RE: EB-2016-0186 – Union Gas Limited (“Union”) – Panhandle Reinforcement Project Responses to Undertakings

UNION GAS LIMITED

Undertaking Response
To Mr. Quinn

TO PROVIDE AN UPDATED VERSION OF J2.1

WINTER DESIGN DAY
PANHANDLE SYSTEM
WINTER 2021/2022
NO ADDITIONAL FACILITIES BUILT

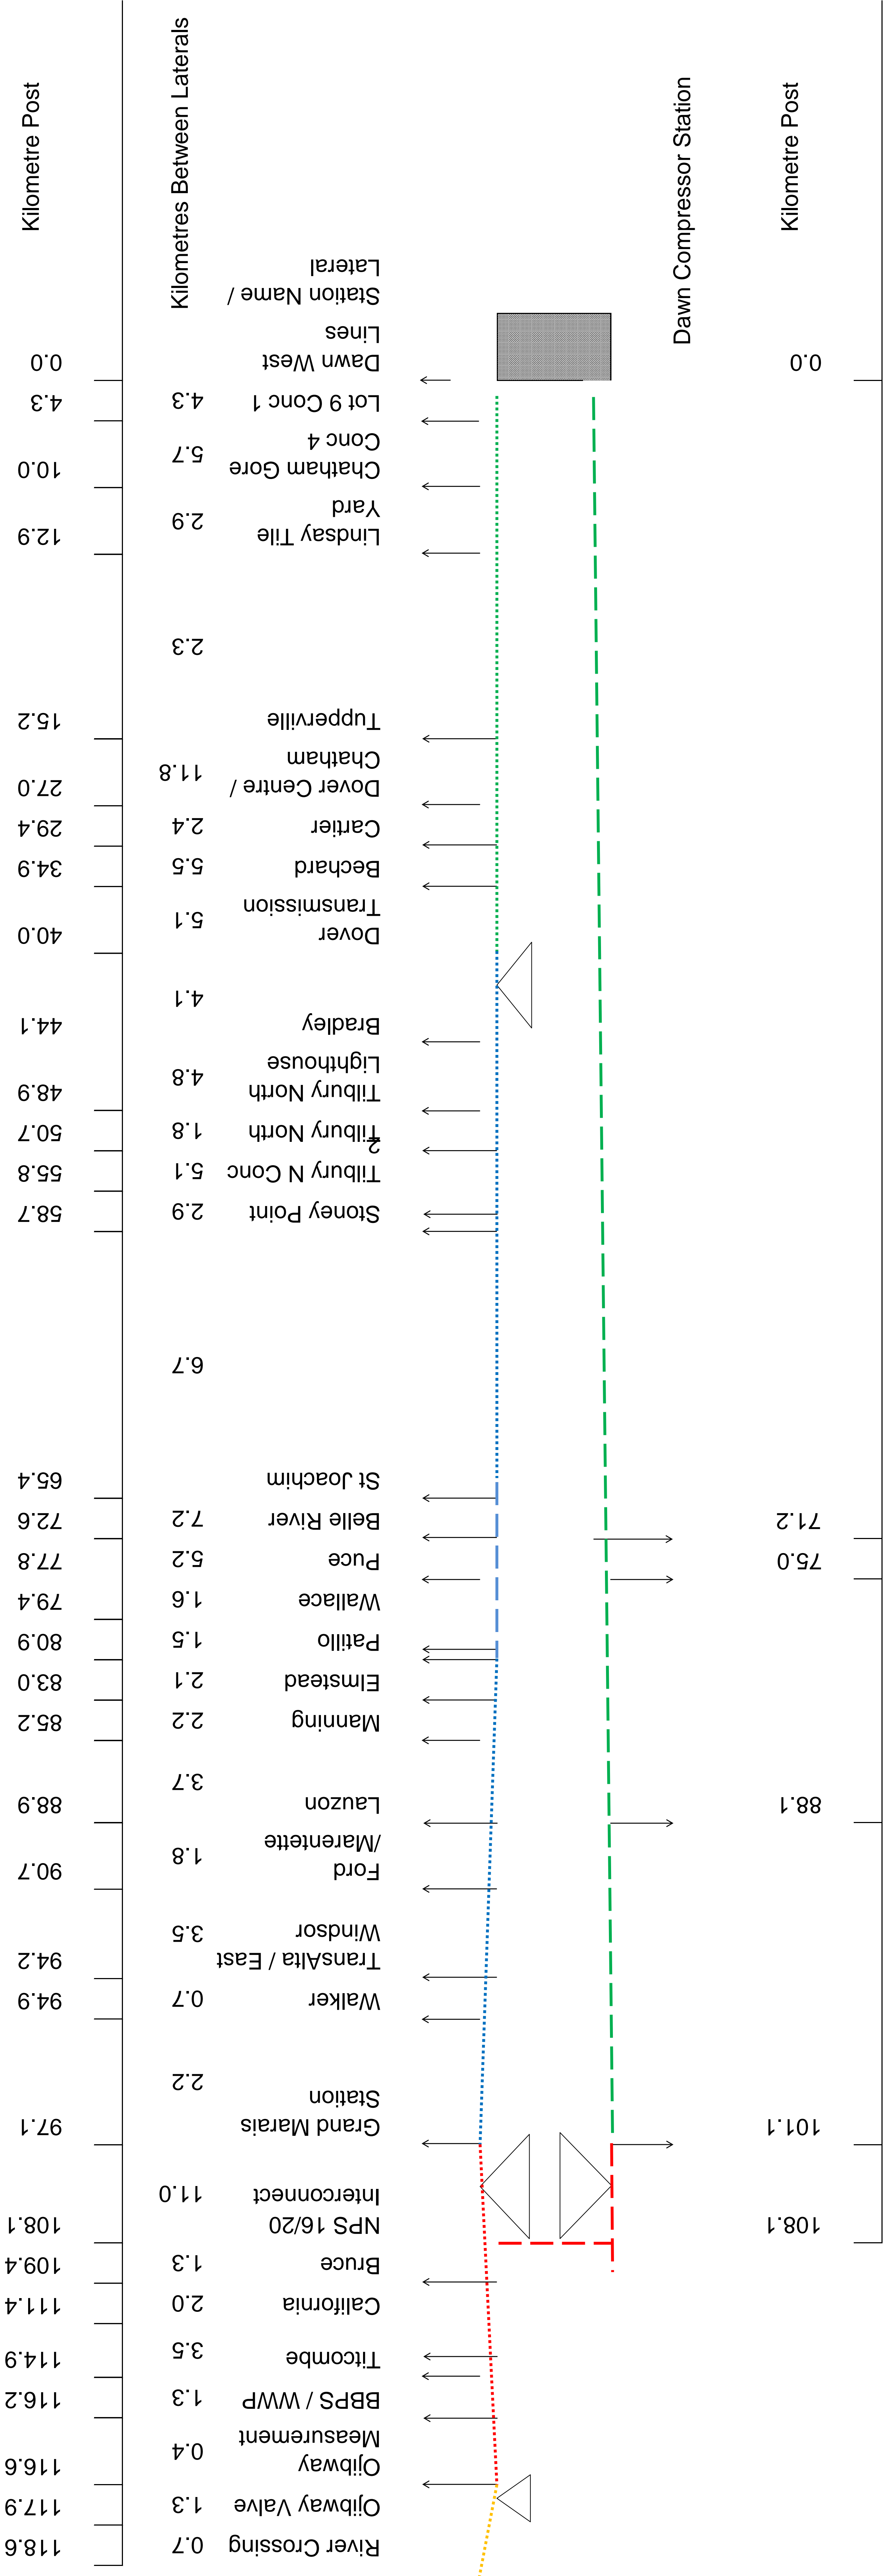
Attachment 1 is an update to the schematic provided in the hearing room in Exhibit J2.1. In J2.1, four pressure figures were inadvertently taken from the inlet of the downstream station rather than from the takeoff on the NPS 20 Panhandle line in the model when preparing and plotting results in Exhibit J2.1. There are no impacts to the model or the model results, including the identified shortfall, only to the pressure labels noted below.

The updated pressures are:

Node/location on system	Pressure at NPS 20 take-off (kPa)	Previously labelled pressure (kPa)
Comber	3741	3618
Mersea	3713	2285
Essex	3661	3213
Sandwich Transmission	3625	3598
